PROJECT THE WORLD TRADE CENTER | TITLE LOUVER SUPPORT REPAIRS - FL.108 | DATE 2/5/71

19-A-991.2

Detail 991E

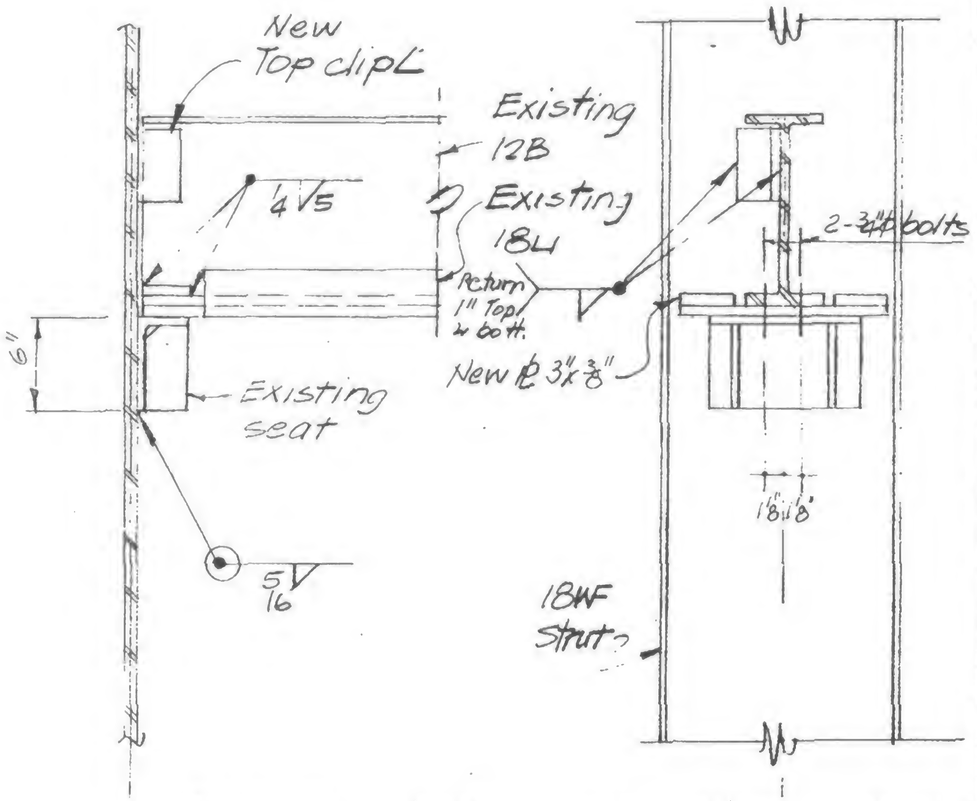
Remove existing connection material, relocate and reweld, rotate existing channel beam assembly and reinstall.
